REQUEST FOR INFORMATION	DATE: October 18, 2016	NO.: RFI-329
--------------------------------	-------------------------------	---------------------

Project Name: 15051-Webster University Interdisciplinary Science Building	Project No.: 15051
---	--------------------

Subject: Added floor box in rm 156 per ASI 30

Drawing Title:
**LEVEL 01 AREA B FLOOR
PLAN - ELECTRICAL &
AUXILIARY**

E0101.B

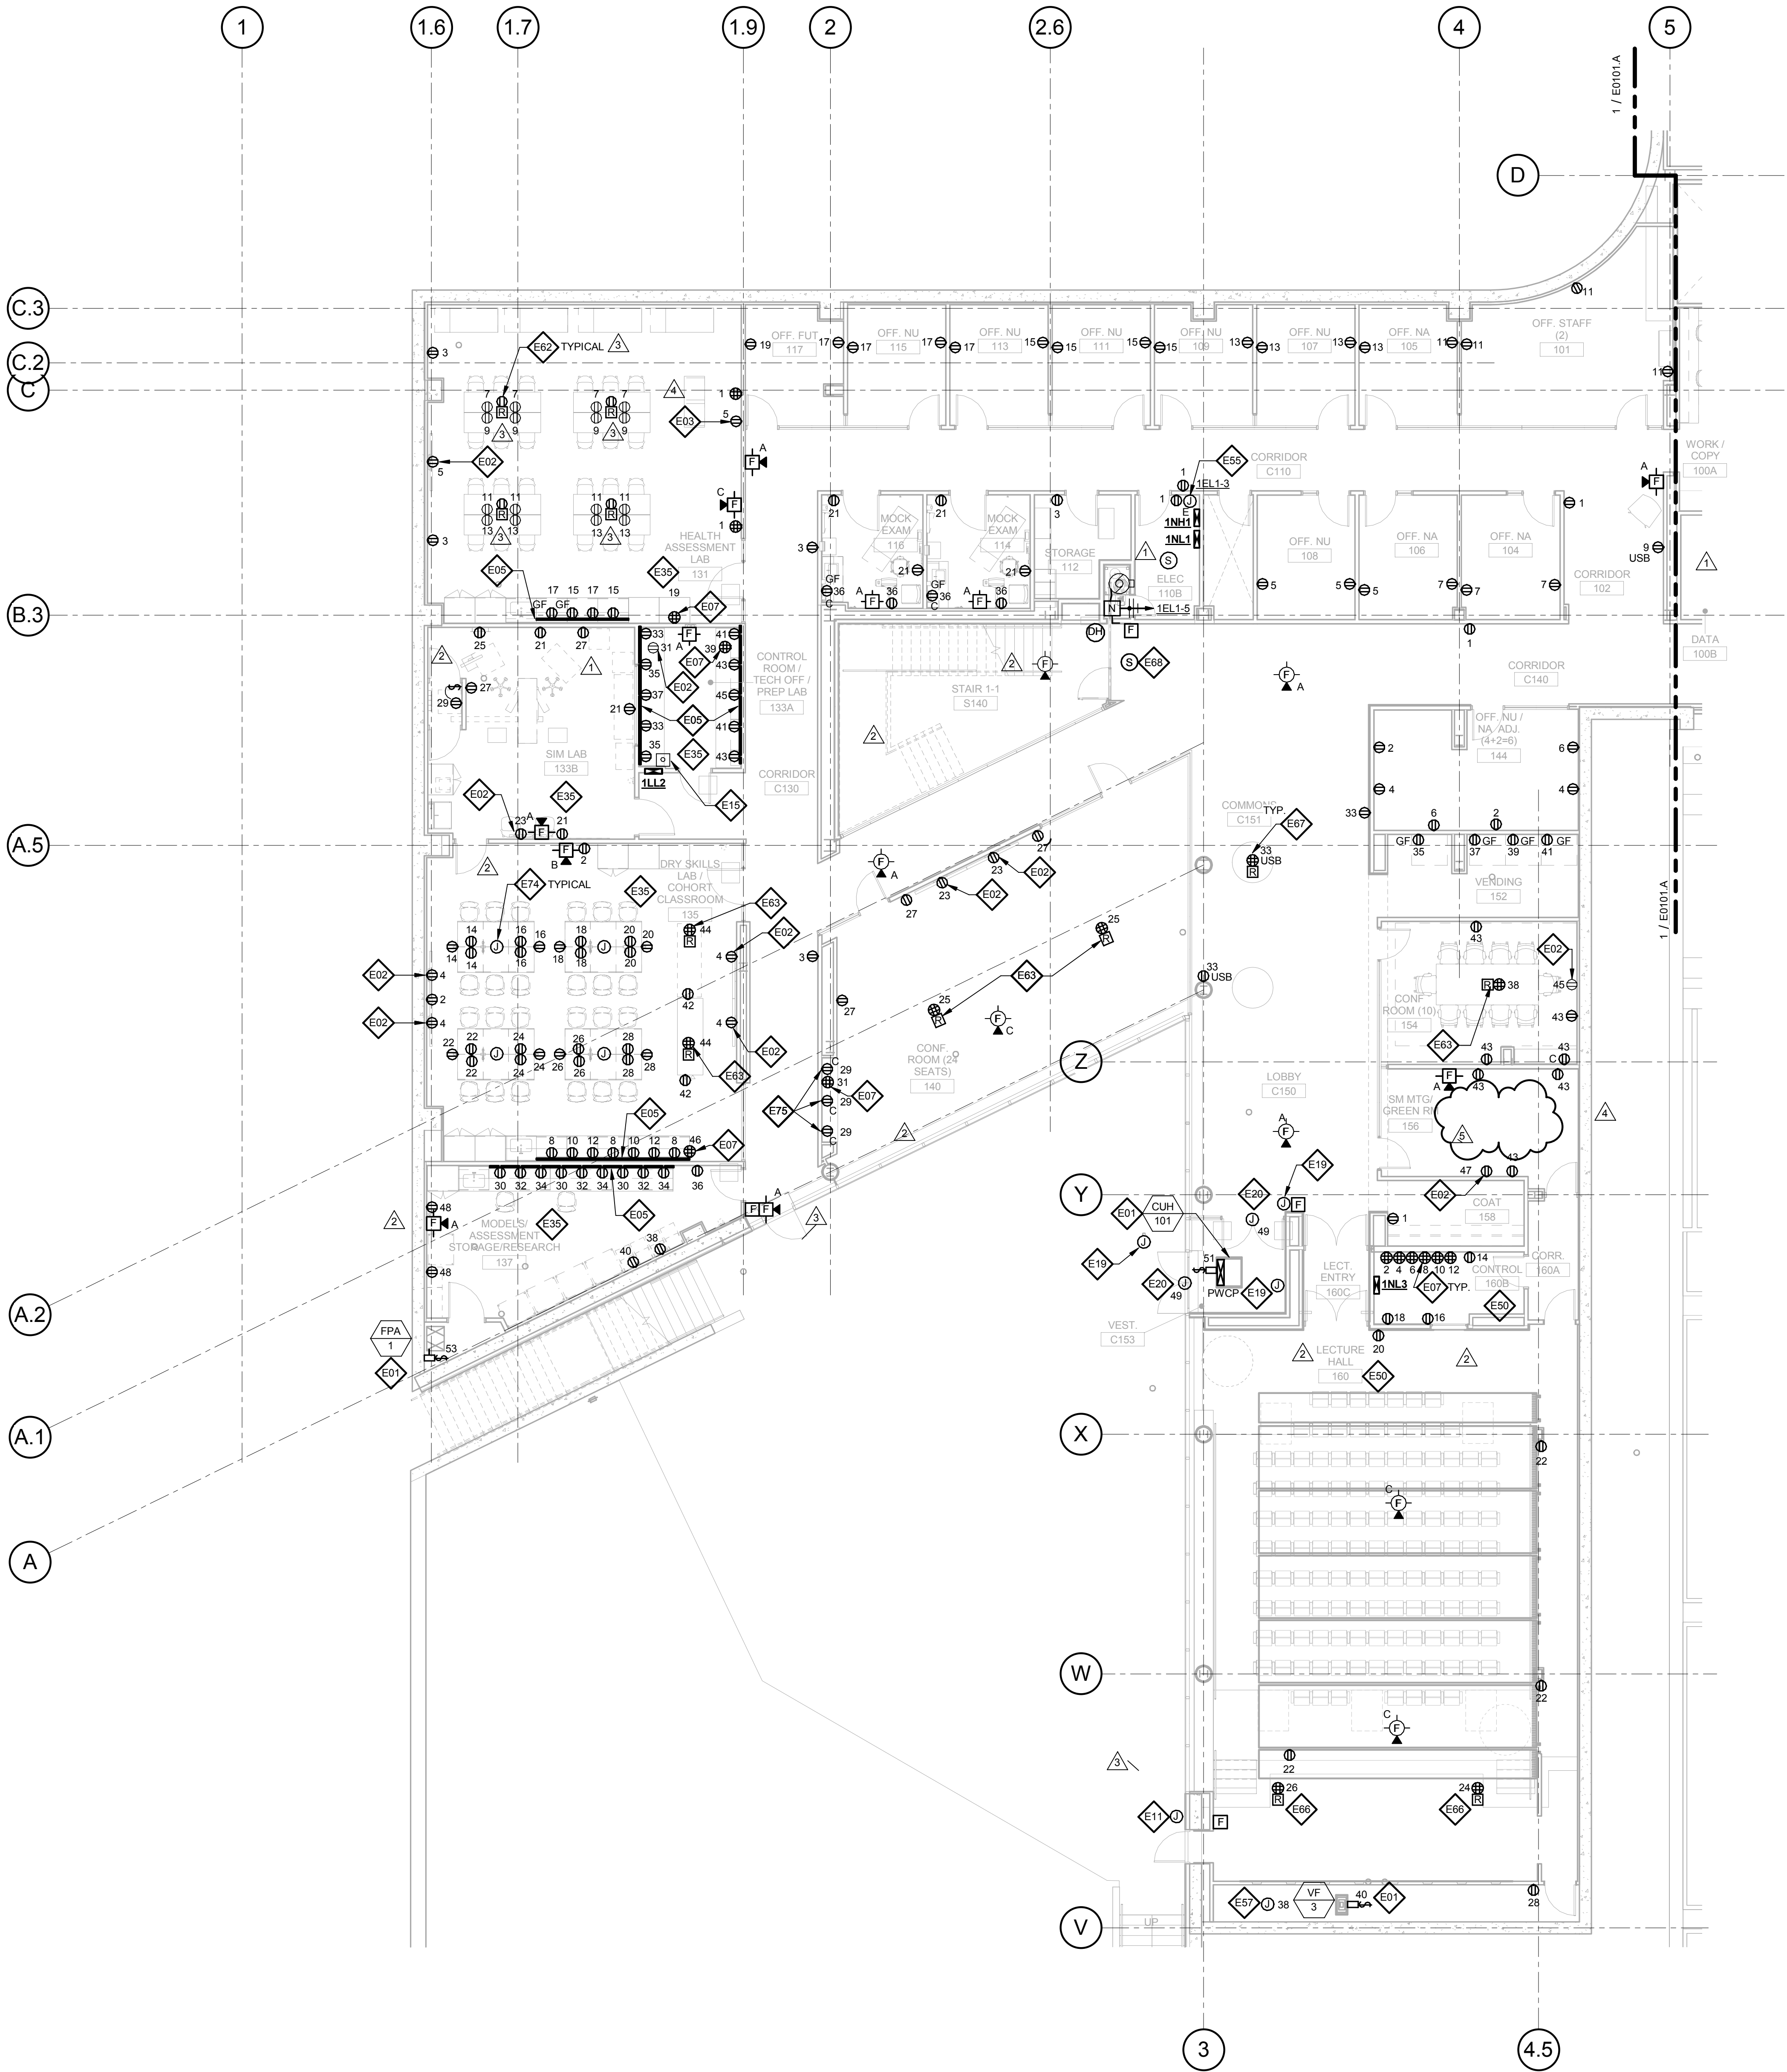
- 1) Please provide dimensions to the added floor box in Room 156.
- 2) Note H. states to refer to technology drawings for conduit rough-in OI Data, voice, and A/V. This information is not listed in the technology drawings. Please provide conduit requirements for the added box.
- 3) This added floor box has a 7 - 10 day lead time which will not work for the scheduled pour date in this area. Contractor proposes to use EFB6S floor box on hand from change at stage area. This is a 6 gang box in lieu of a 4 gang box and the cover can be finalized after the concrete placement.

Delete the floor box in Room 156. See attached drawing.
